NOTICE OF VIOLATION

On January 16, 2025, Energy Safety conducted an inspection of PG&E's WMP initiatives in the vicinity of the city of Pine Grove, California. The inspection report is enclosed herewith. Energy Safety found the following violation(s):

INSPECTION REPORT

Violation 1

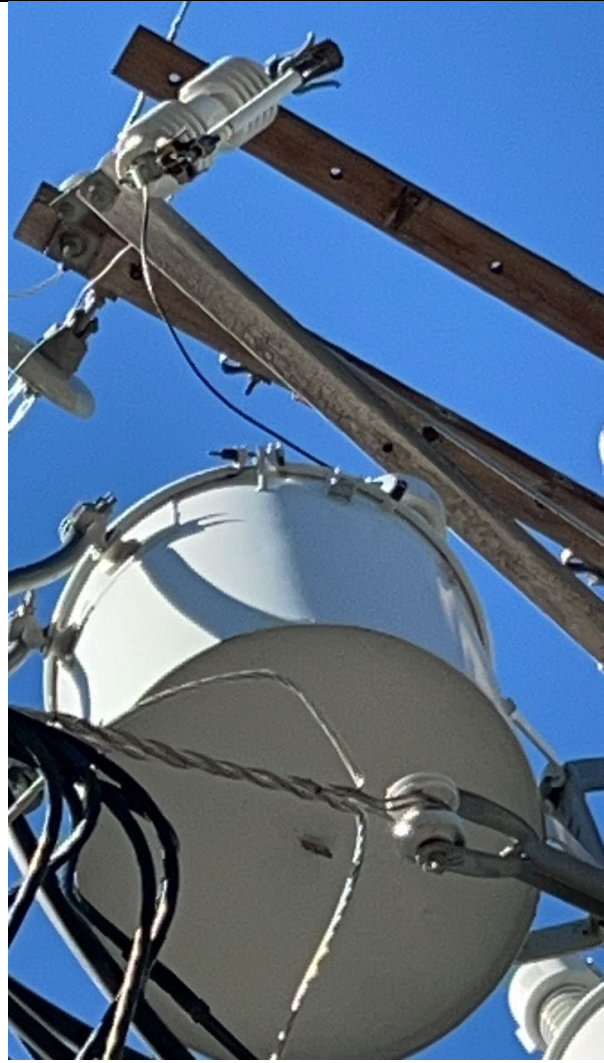
On pole ID 121249428, Grid Hardening ID 31658885, at 20220 State Highway 88, Pine Grove, CA, 95665, USA, 38.410487, -120.652408, the inspector observed that the pole had non-exempt expulsion fuses that PG&E reported had been replaced. The inspector's observation is documented in Violation 1 photographs, which are attachments to this report. Photo numbers Item1Gimg1, Item1IA1img1, and Item1IA1img2 depict the three non-exempt expulsion fuses still on the pole. PG&E reported that work on WMP initiative 8.1.2.10.5 – Non-Exempt Expulsion Fuses was completed at this location.

1. Three non-exempt expulsion fuses were observed at this location.
